CERTIFICATE OF APPROPRIATENESS

Property: 919 West Melwood Street, Lot 14, Block 204, East Norhill Subdivision. The property includes a historic 1,016 square foot one-story wood frame single family residence and detached garage situated on a 5,200 square foot (50' x 104') interior lot.

Proposal: Alteration – Addition.

Basis for Issuance: HAHC Approval
Effective: March 23, 2017

EAST SIDE ELEVATION

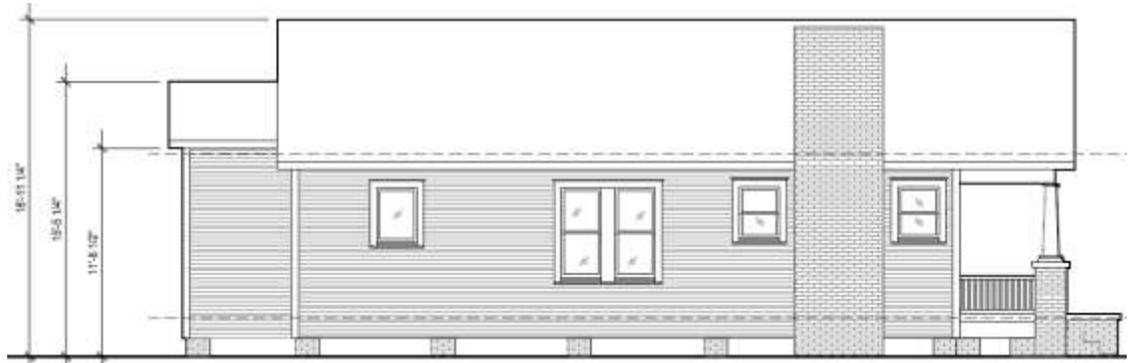
| <input type="checkbox"/> | <input checked="" type="checkbox"/> | <input type="checkbox"/> | (3) The proposed activity must recognize the building, structure, object or site as a product of its own time and avoid alterations that seek to create an earlier or later appearance; <i>The installation of a horizontally oriented fixed window is a characteristic of a more contemporary structure and not a 1920s bungalow. Staff believes that a window may have originally been installed in this location, but if a new window is to be installed it should match the smaller 1-over-1 double-hung windows located in other locations of the house. This would be more compatible with the age of this structure.</i> |
| <input type="checkbox"/> | <input checked="" type="checkbox"/> | <input type="checkbox"/> | (7) The proposed replacement of missing exterior features, if any, should be based on an accurate duplication of features, substantiated by available historical, physical or pictorial evidence, where that evidence is available, rather than on conjectural designs or the availability of different architectural elements from other structures; <i>The installation of a horizontally oriented fixed window is a characteristic of a more contemporary structure and not a 1920s bungalow. Staff believes that a window may have originally been installed in this location, but if a new window is to be installed it should match the smaller 1-over-1 double-hung windows located in other locations of the house. This would be more compatible with the age of this structure.</i> |

HAHC Action: Approved with Conditions: Replacement of the non-original window on the west elevation is appropriate but the new window should fit into the existing opening so that the opening and trim are left unaltered. On the east elevation, if evidence is uncovered of an original window location, a new window should be installed in the original opening and the new window should match the smaller 1-over-1 double-hung windows located in other locations of the house.

WEST SIDE ELEVATION

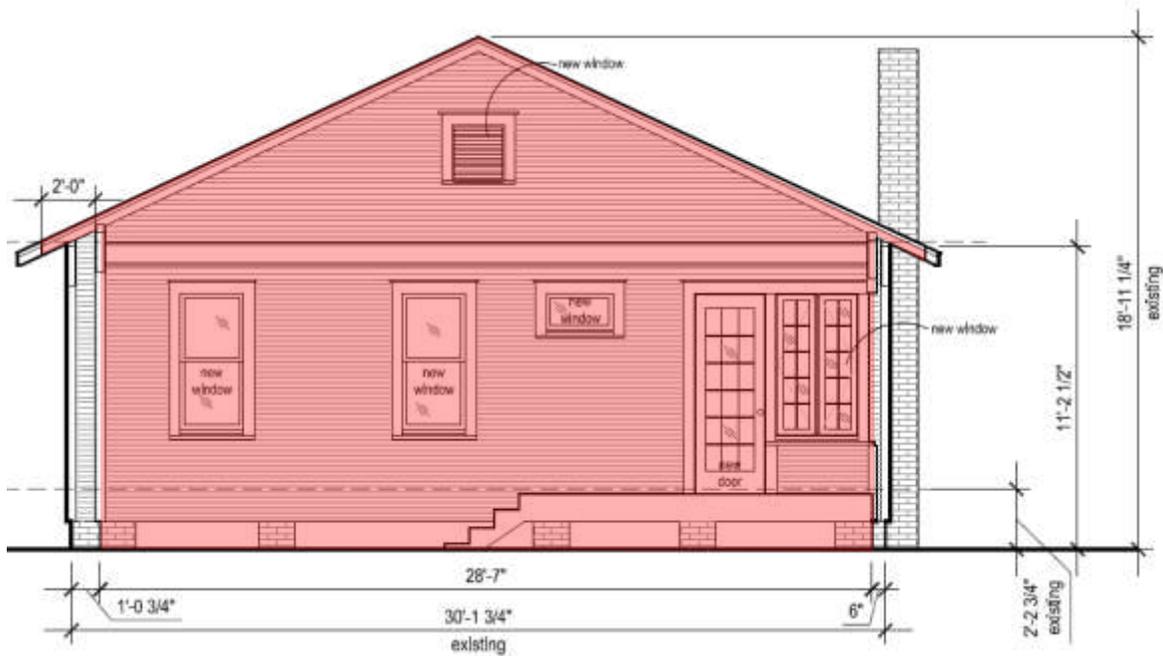
Recommendation: Approval with conditions: Replacement of the non-original window on the west elevation is appropriate but the new window should fit into the existing opening so that the opening and trim are left unaltered. On the east elevation, if evidence is uncovered of an original window location, a new window should be installed in the original opening and the new window should match the smaller 1-over-1 double-hung windows located in other locations of the house.

| | <input checked="" type="checkbox"/> | <input type="checkbox"/> | (1) The proposed activity must retain and preserve the historical character of the property; <i>Expanding the single window opening on the west elevation as well as creating a new window opening on the east elevation will alter the historical character of the property by altering the original fenestration pattern.</i> |
| <input type="checkbox"/> | <input checked="" type="checkbox"/> | <input type="checkbox"/> | (4) The proposed activity must preserve the distinguishing qualities or character of the building, structure, object or site and its environment; <i>Alteration of the single small window opening on the west elevation to a pair of windows does not preserve the distinguishing character of the existing building since it alters the original fenestration pattern and leads to the destruction of historic trim and siding material. The non-original window may be replaced but the new window should fit into the existing opening so that the opening and trim are left unaltered. Any new window on the original portion of the house should be 1-over-1 inset and recessed to match the other original windows.</i> |
